REMARKS

Serial No. 09/888,400

Marked-Up Version of Changes Made

HANA 2001-P-31
FIG. 1a

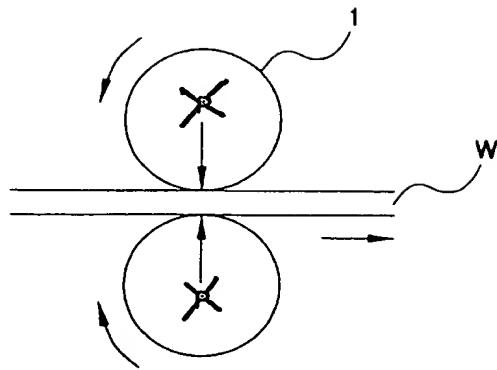
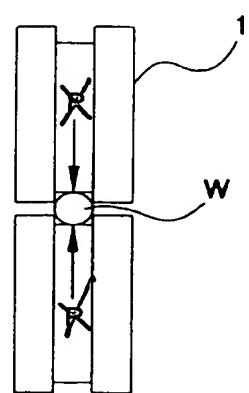
the residual stress deviation in a radial direction of the wire W becomes greater. This results in a greater difference of hardness between one outside and the other outside of the wire W. As a consequence, the wire W is twisted if it fails to resist continuous partial load (refer to Figs. 1A and 1B) laid thereon when the wire W passes through a feeding roller in the course of welding, thereby resulting in vibration of the tip of the wire W that might cause an arc instability. Further, [when the contact area of the portion where the wire W is actually reduced is excessively large] when there is excessively large the diameter reducing contact part 20 for actually reducing the diameter of the wire W, a partial work hardening occurs, thereby lowering the quality of surface of the wire W. In the worst case, the partial stress deviation between the inside (central portion) and outside of the wire W becomes greater, thereby disabling drawing of the wire W.

Fig.2

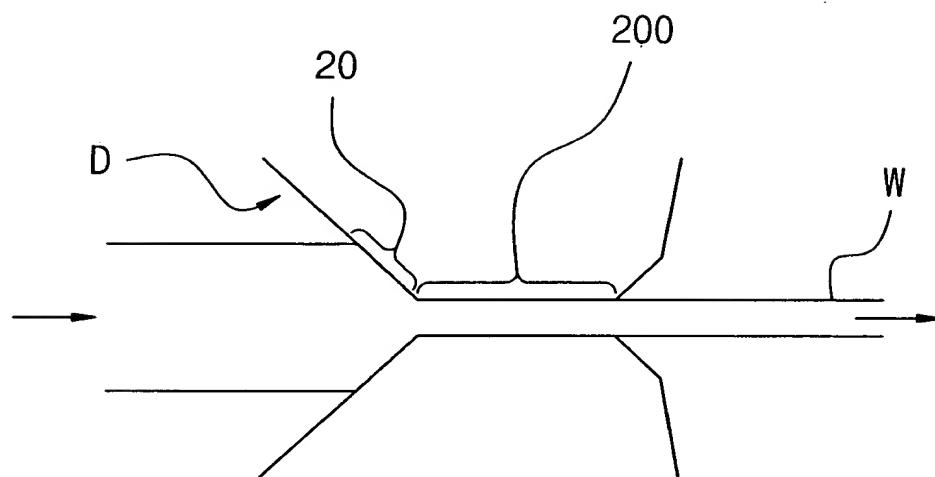
Fig. 2 is a diagram illustrating [a reducing contact area 20 and a correction contact area 200 when a wire W passes through dies D] a diameter reducing contact part 20 for reducing a diameter of a wire W and a diameter correcting contact part 200 (a bearing part) for correcting the diameter of the wire W when the wire W passes through die D.

The contact area between the wire W and the [dies] die D is mainly determined by the following factors: i) a contact area of the [dies] die D with the wire W in which actual diameter reduction of the wire W is performed; and ii) straightness of the wire and a contact area of the wire W with [a] the bearing part 200 in accordance with the straightness. The diameter of the W wire is corrected by [a] the bearing part 200 so as to have an enhanced straightness.
